PRODUCT CHANGE NOTIFICATION (PCN)

AMJG0808-1000-BKB-26 MODULAR CABLE

CHANGE NOTIFICATION:	PCN 20220425_AMJG0808-xxxx-xxB-26
DESCRIPTION OF CHANGES:	CHANGE OF DATA SHEET CHANGE OF DATA SHEET New Draw.-No. ASS_7947_CArev02
REASON FOR CHANGE:	CHANGE OF PRODUCT LOCATION CHANGE OF PRODUCT LOCATION
KEY CHARACTERISTICS OF CHANGE:	Details see page 3
PRODUCTS AFFECTED:	AMJG0808-1000-BKB-26
DATE OF CHANGE AND IMPLEMENTATION:	CHANGE: WEEK 18 / YEAR 2022 IMPLEMENTATION: 25/4/2022
RESPONSE:	NO RESPONSE TO THIS NOTIFICATION IS REQUIRED

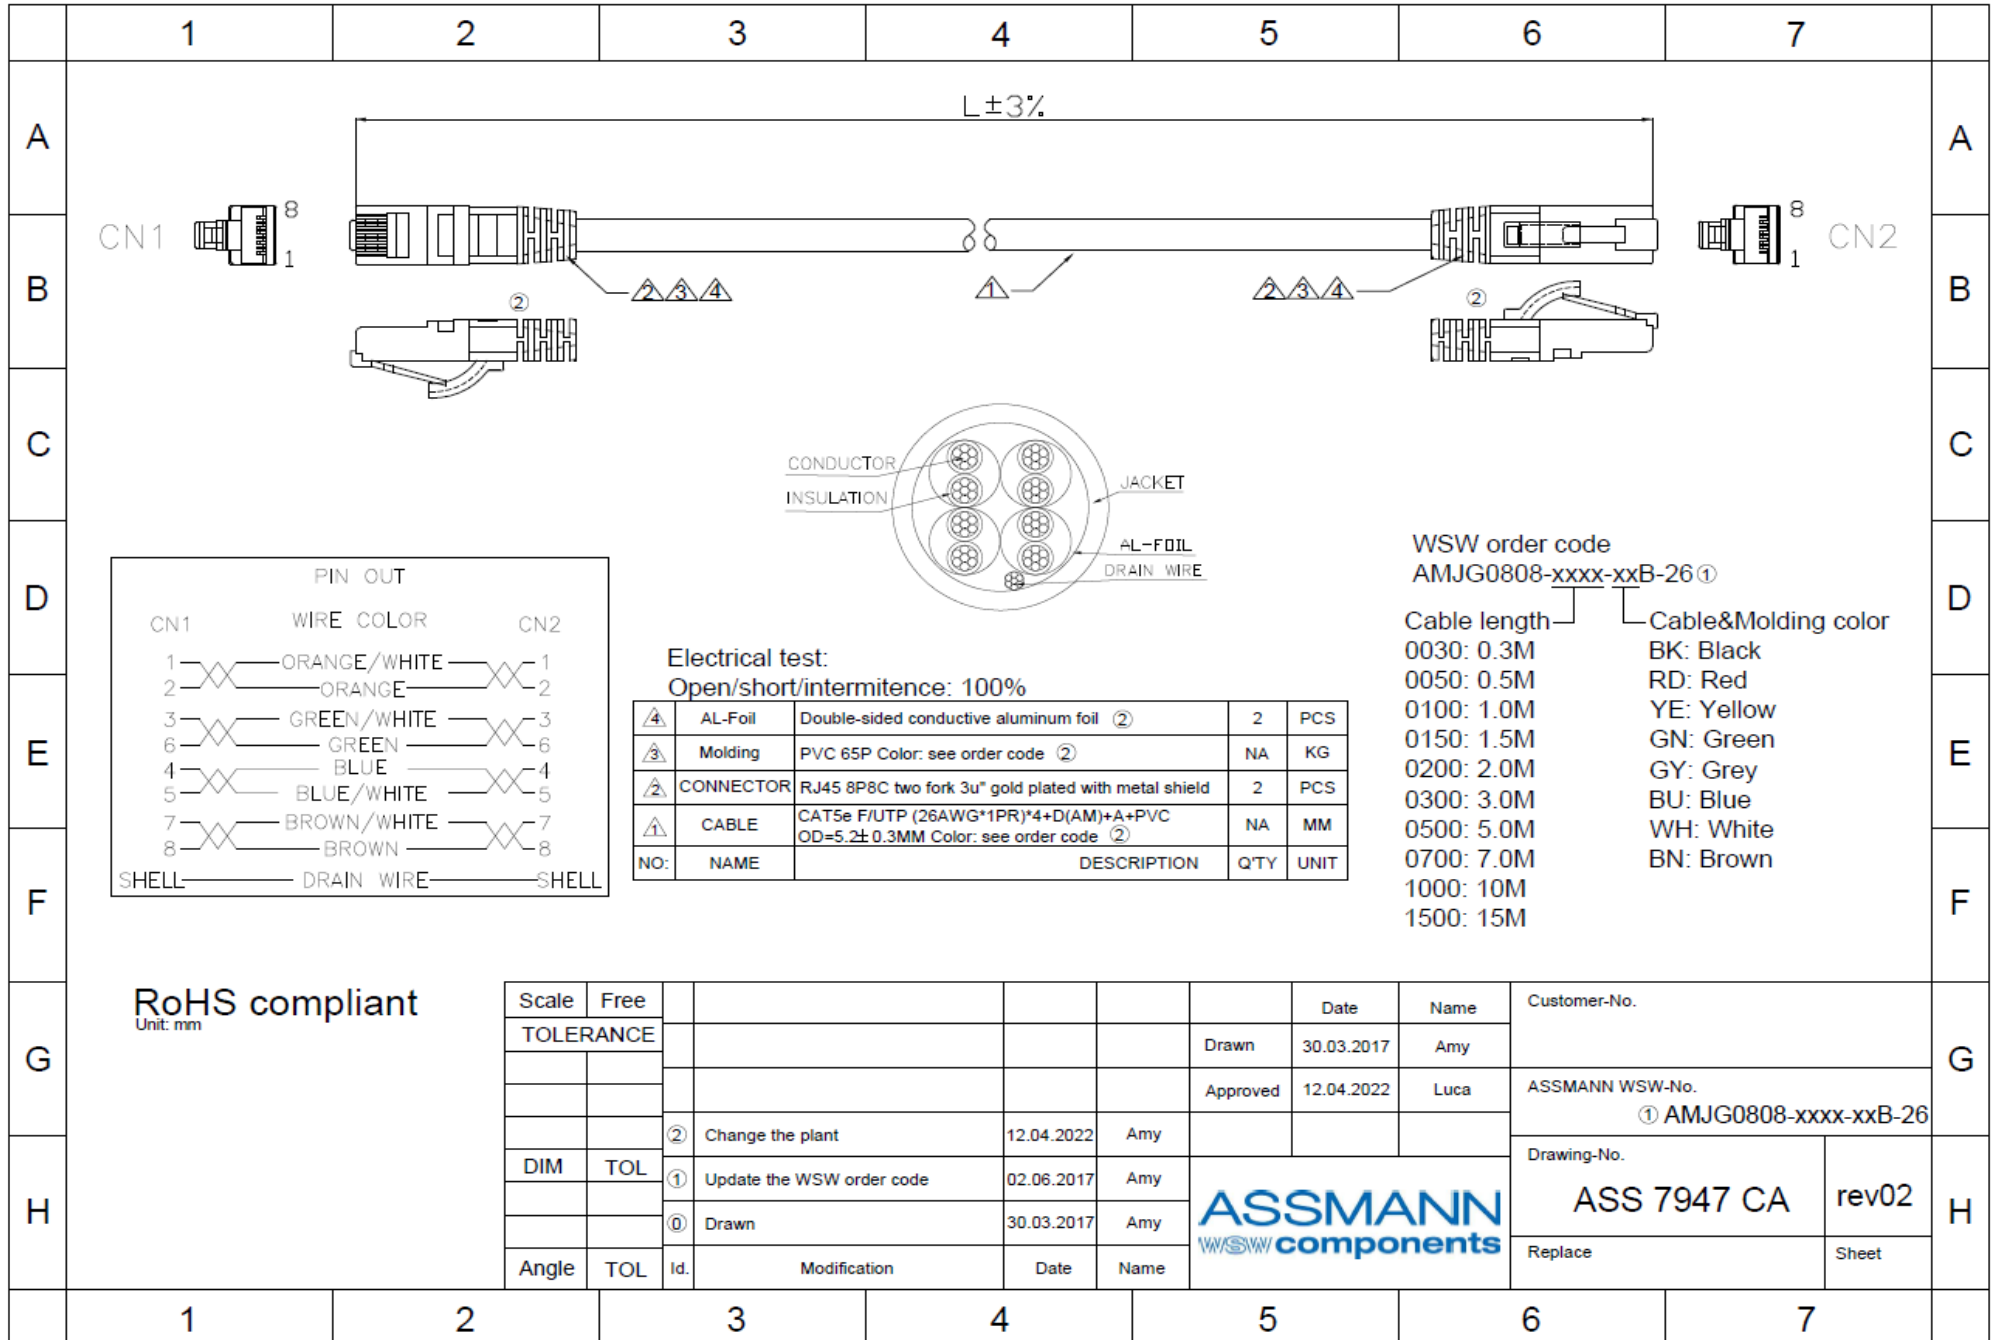
AMJG0808-1000-BKB-26	OLD VERSION	AMJG0808-1000-BKB-26	NEW VERSION																																													
<p>Appearance</p>		<p>Appearance</p>																																														
<p>BOM</p> <table border="1"> <thead> <tr> <th>NO:</th> <th>NAME</th> <th>DESCRIPTION</th> <th>Q'TY</th> <th>UNIT</th> </tr> </thead> <tbody> <tr> <td>③</td> <td>Molding</td> <td>PVC 45P Color: see order code</td> <td>NA</td> <td>KG</td> </tr> <tr> <td>②</td> <td>CONNECTOR</td> <td>RJ45 8P8C two fork 3u" gold plated with metal shield</td> <td>2</td> <td>PCS</td> </tr> <tr> <td>①</td> <td>CABLE</td> <td>CAT5e FTP (26AWG*1PR)*4+D+A+PVC OD=5,2±0,3MM Color: see order code</td> <td>NA</td> <td>MM</td> </tr> </tbody> </table>		NO:	NAME	DESCRIPTION	Q'TY	UNIT	③	Molding	PVC 45P Color: see order code	NA	KG	②	CONNECTOR	RJ45 8P8C two fork 3u" gold plated with metal shield	2	PCS	①	CABLE	CAT5e FTP (26AWG*1PR)*4+D+A+PVC OD=5,2±0,3MM Color: see order code	NA	MM	<p>BOM</p> <table border="1"> <thead> <tr> <th>NO:</th> <th>NAME</th> <th>DESCRIPTION</th> <th>Q'TY</th> <th>UNIT</th> </tr> </thead> <tbody> <tr> <td>⚠</td> <td>AL-Foil</td> <td>Double-sided conductive aluminum foil ②</td> <td>2</td> <td>PCS</td> </tr> <tr> <td>⚠</td> <td>Molding</td> <td>PVC 65P Color: see order code ②</td> <td>NA</td> <td>KG</td> </tr> <tr> <td>⚠</td> <td>CONNECTOR</td> <td>RJ45 8P8C two fork 3u" gold plated with metal shield</td> <td>2</td> <td>PCS</td> </tr> <tr> <td>⚠</td> <td>CABLE</td> <td>CAT5e F/UTP (26AWG*1PR)*4+D(AM)+A+PVC OD=5,2±0,3MM Color: see order code ②</td> <td>NA</td> <td>MM</td> </tr> </tbody> </table>		NO:	NAME	DESCRIPTION	Q'TY	UNIT	⚠	AL-Foil	Double-sided conductive aluminum foil ②	2	PCS	⚠	Molding	PVC 65P Color: see order code ②	NA	KG	⚠	CONNECTOR	RJ45 8P8C two fork 3u" gold plated with metal shield	2	PCS	⚠	CABLE	CAT5e F/UTP (26AWG*1PR)*4+D(AM)+A+PVC OD=5,2±0,3MM Color: see order code ②	NA	MM
